AMENDMENT OF SOLICITATION/MODIFICATION OF CONTRACT				1. CONTRACT ID CODE	PAGE OF PAGES
				J	1 17
2. AMENDMENT/MODIFICATION NO. 0001	3. EFFECTIVE DATE 28-Mar-2003	4. REQUISITION/PURCHASE REQ. NO. W26GLG-3063-7185		5. PROJECT NO.(If applicable)

14. DESCRIPTION OF AMENDMENT/MODIFICATION (Organized by UCF section headings, including solicitation/contract subject matter where feasible.)					
2ND ACCESS ROAD BRIDGE CROSSING, FORT EUSTIS, VIRGINIA

SECTION SF 30 BLOCK 14 CONTINUATION PAGE

SK-2

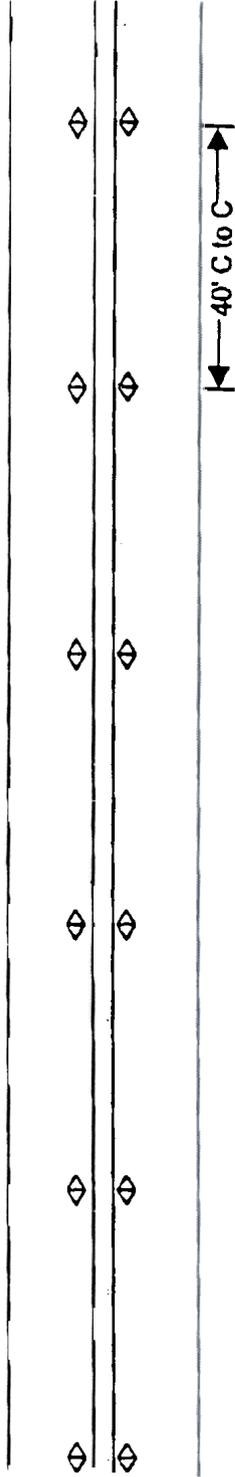
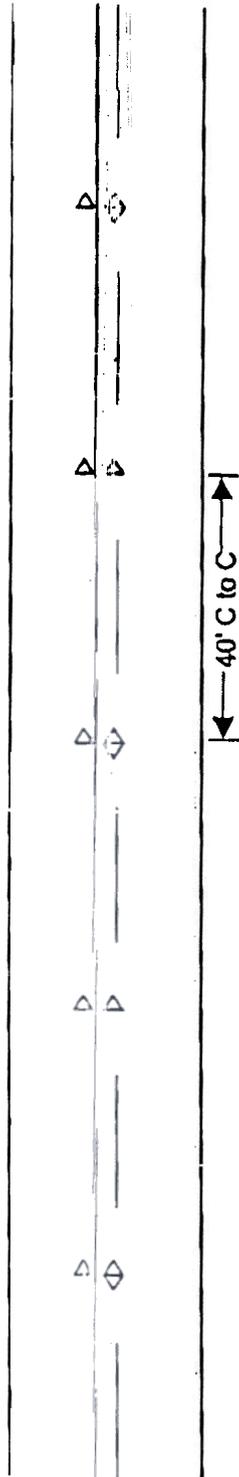
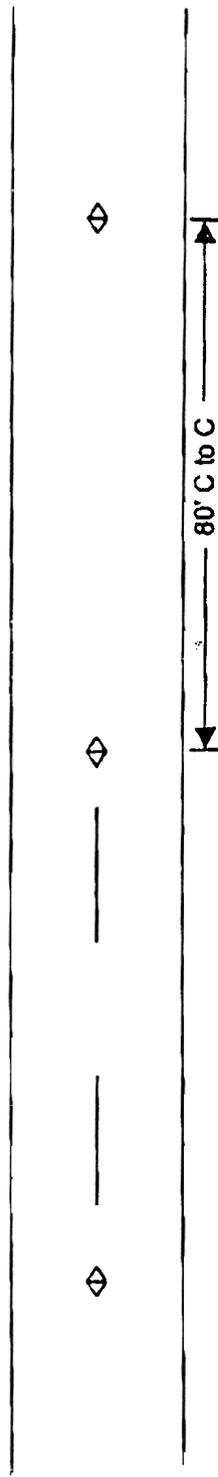
C-101 – C-120 Striping Plans: To augment lane line striping the Contractor shall provide Retroreflectors of the Recessed and Snow Plowable Raised Pavement Marker type per Section 235 of the VDOT RBS. Markers shall be provided in all lane lines and edge lines. Marker spacing shall be as shown on the attached sketches SK-1 and SK-2. Marker selection and layout shall be as approved by the City of Newport News, Dept of Engineering.

SECTION A-A
SECTION STRAND PATTERNS
FOR PILES WITH S.R. STRANDS

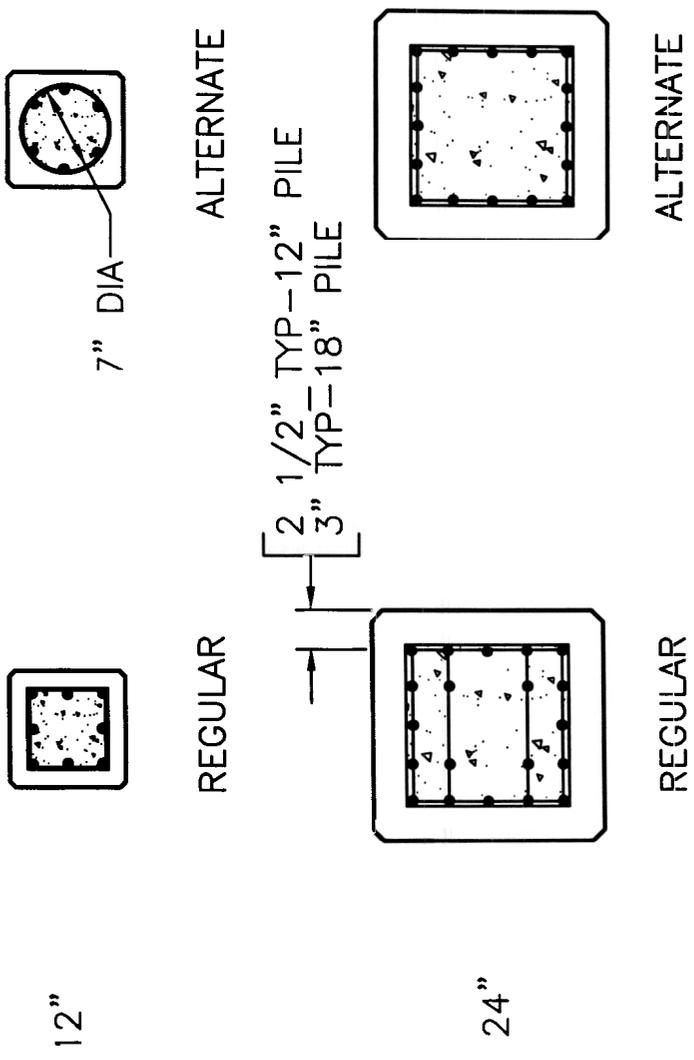
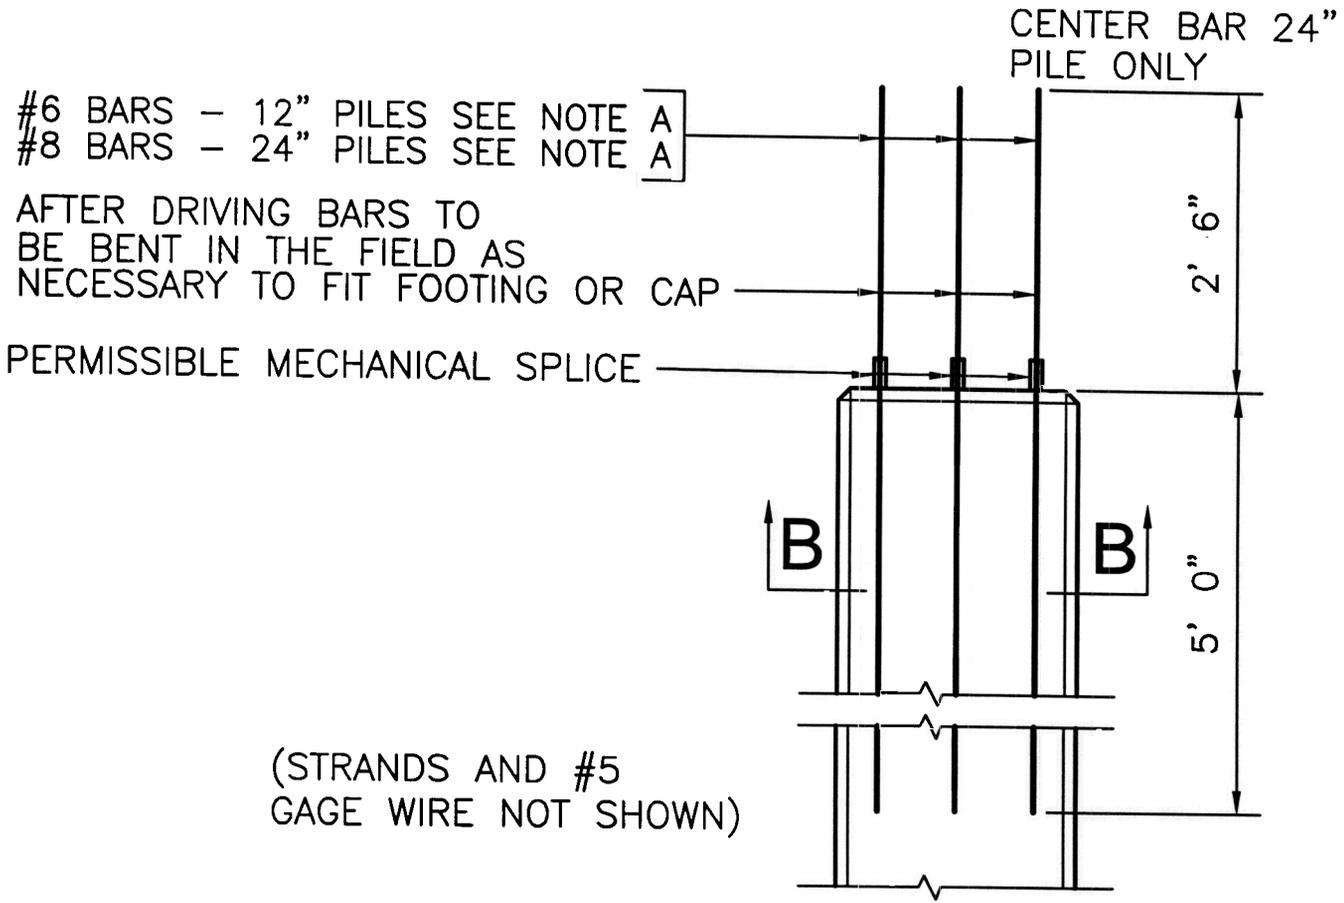
Sht S313.Delete drawing: Section A-A Section Strand Patterns For Piles With S.R. Strands.

Add attached drawing: Section A-A Section Strand Patterns For Piles With S.R. Strands.

SECTION B-B PILE HEAD

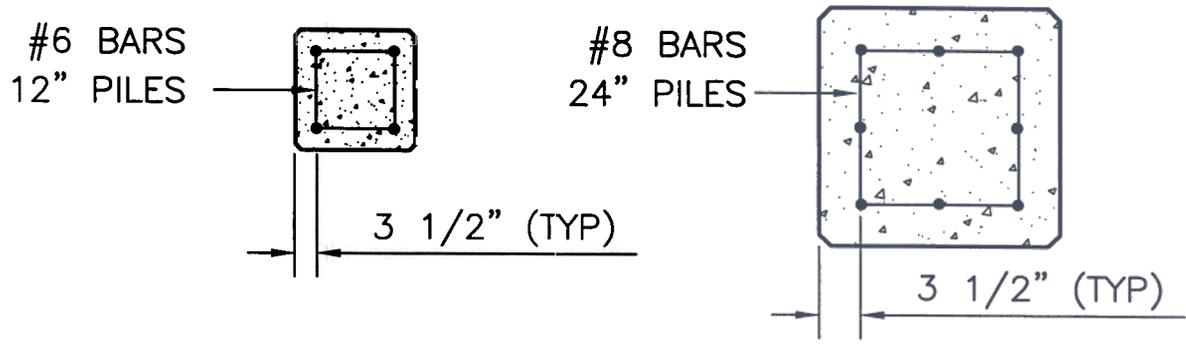
Sht S313. Delete drawing: Elevation & Section B-B Pile Head. ***Add attached drawing:*** Elevation & Section B-B Pile Head.

ABUTMENT SLEEVE DETAIL

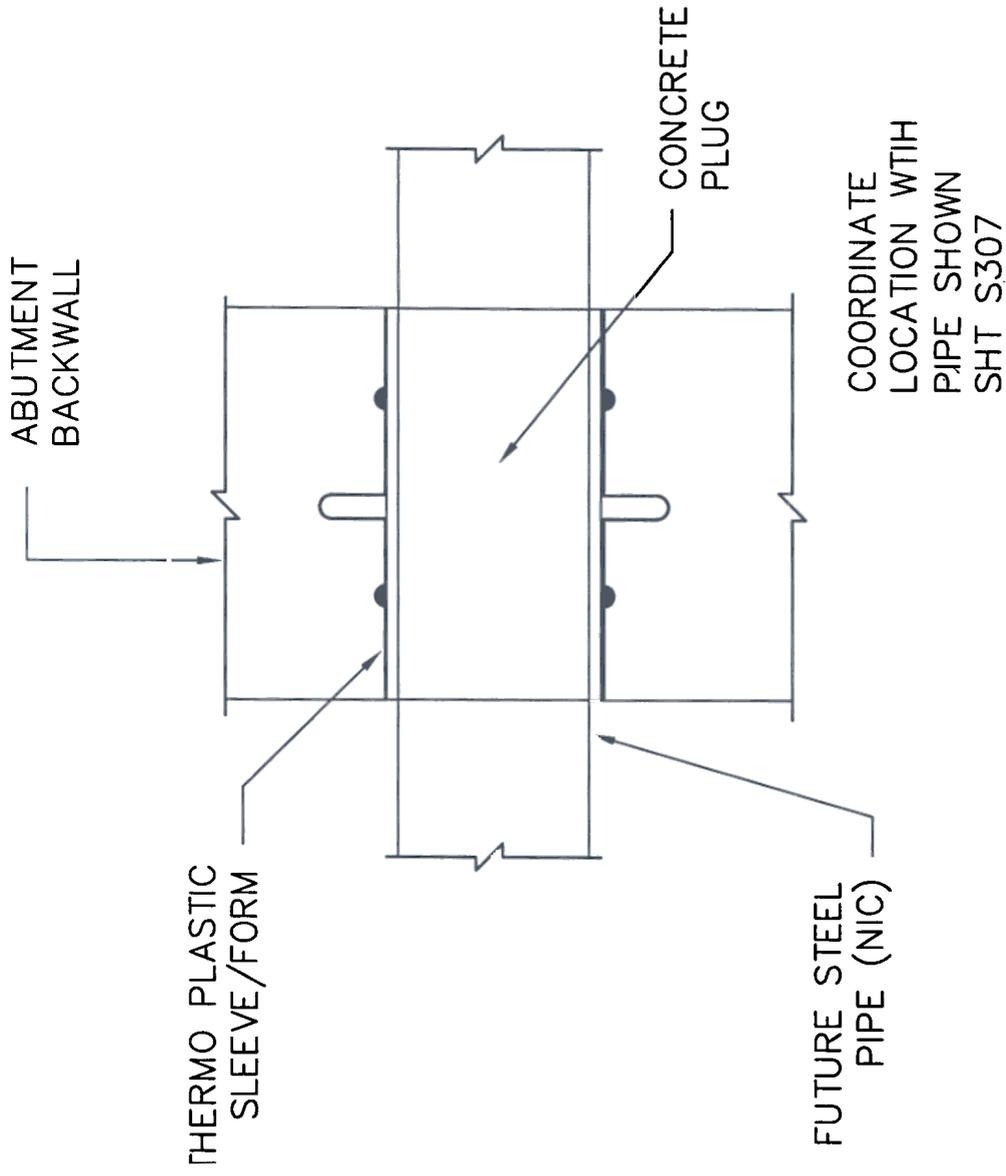
Sht S304. Add attached detail: Abutment sleeve Detail- Abutment C & D
